DYKES ROAD FARMETTES SUBDIVISION,
RESUBDIVISION OF LOT 5

APPLICATION NUMBER 11 DATE January 16, 2014
APPLICANT Dykes Road Farnettes Subdivision, Resubdivision of Lot 5
REQUEST Subdivision

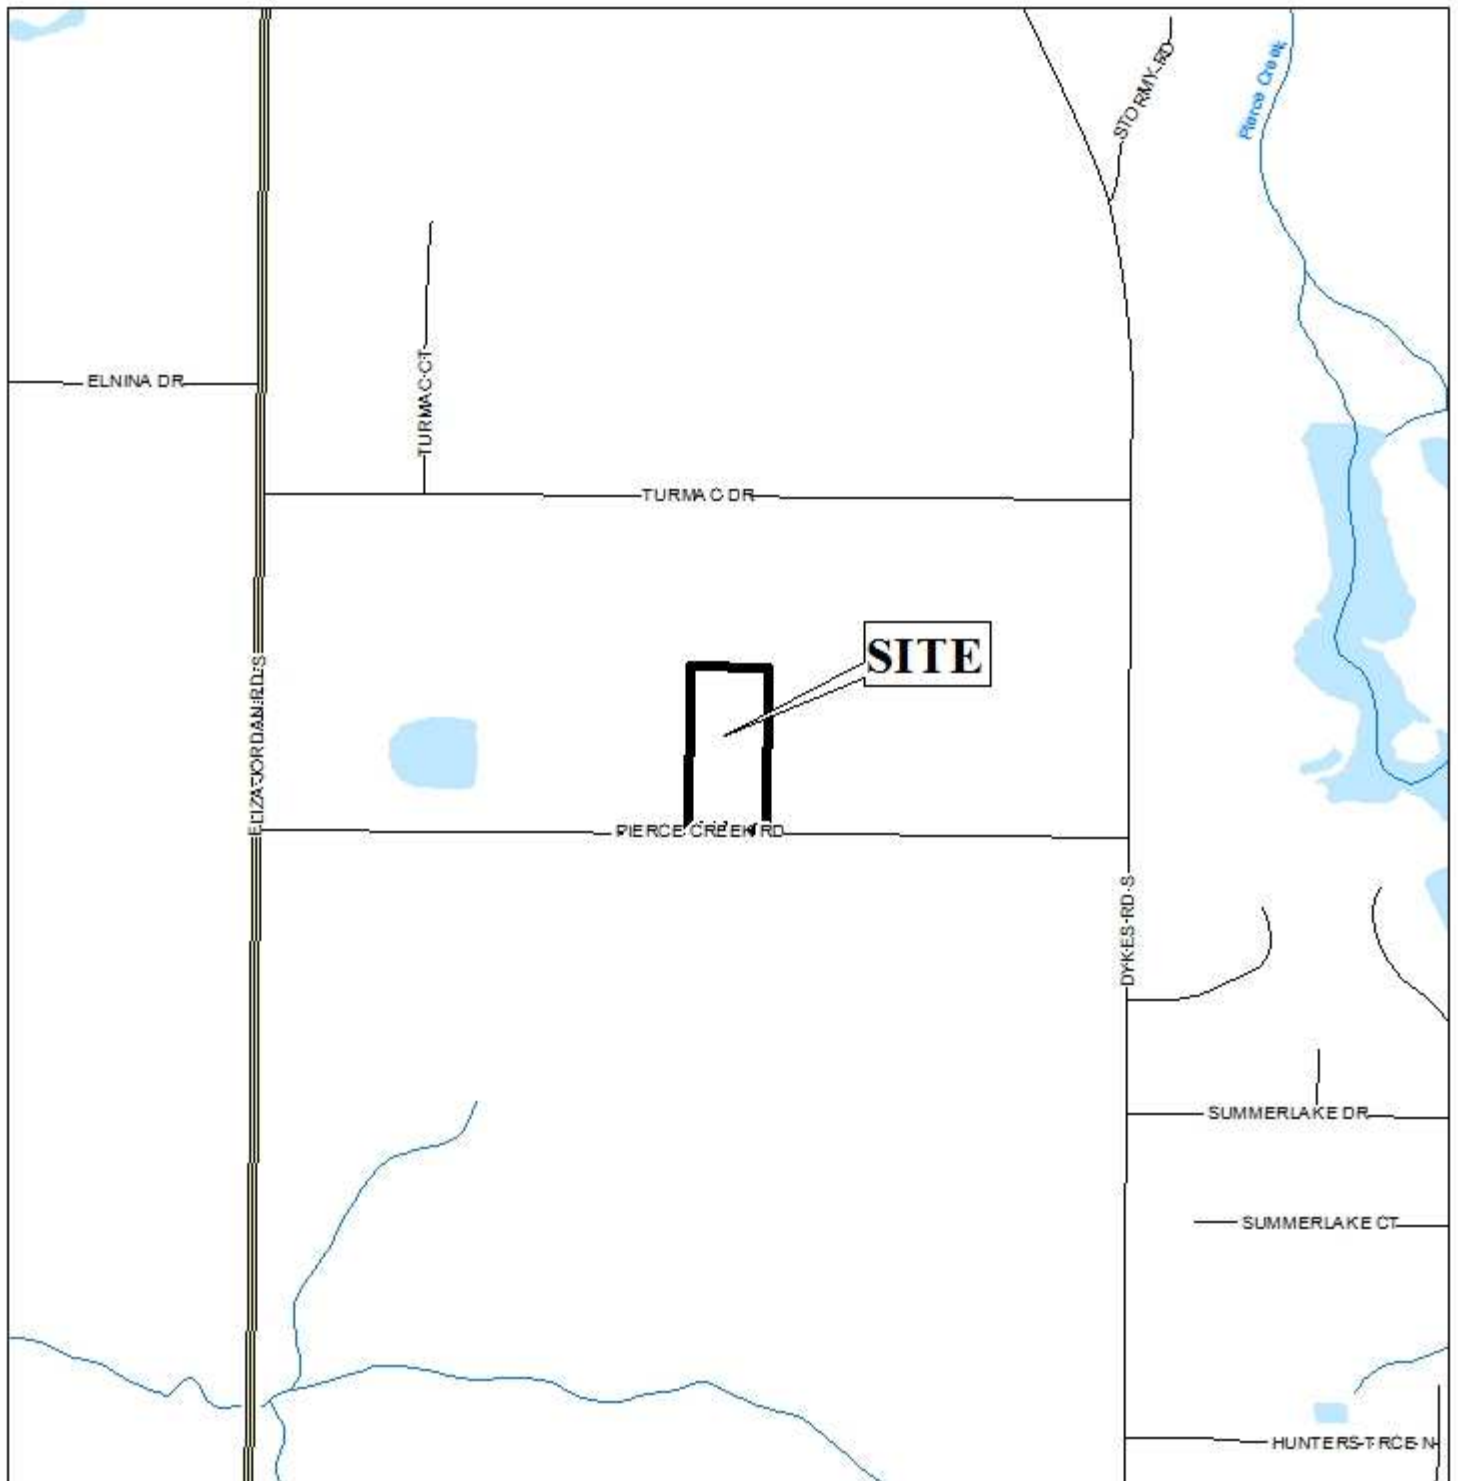
The plat illustrates the proposed 2.62 acre \pm , 2 lot subdivision which is located on the North side of Pierce Creek Road, 1030' \pm West of Dykes Road South. The applicant states that the subdivision is served by public water and septic tanks.

The proposed Lot 2 meets the minimum size and frontage requirements as regulated by Section V.D.2. of the Subdivision Regulations.

The proposed Lot 1 is a flag lot, and, while meeting the minimum width of 25 feet for a flag lot, the applicant did not provide any information stating unusual circumstance which may exist on the lot, or if there is a natural or pre-existing man-made barrier which may cause an undue hardship. Flag lots are generally not allowed, and there appears to be only one flag lot in the immediate vicinity of the site which was approved by Planning Commission in September 2003. However, the proposed lot does not seem to satisfy the requirements of Section V.D.1. of the Subdivision Regulations and no justification was provided.

The 25-foot minimum building setback line and the lot area sizes, in square feet, are depicted on the plat, and should be retained on the final plat, if approved.

The proposed lots have frontage along Pierce Creek Road, a minor street not provided with curb and gutter and with an existing right-of-way of 60 feet. As a means of access management, each lot should be limited to a single curb cut, to Pierce Creek Road with the size, location and design of all curb-cuts to be approved by Mobile County Engineering and conform to AASHTO standards.

Based on the preceding, this application is recommended for Denial do to the proposed flag lot, with no submitted justification.
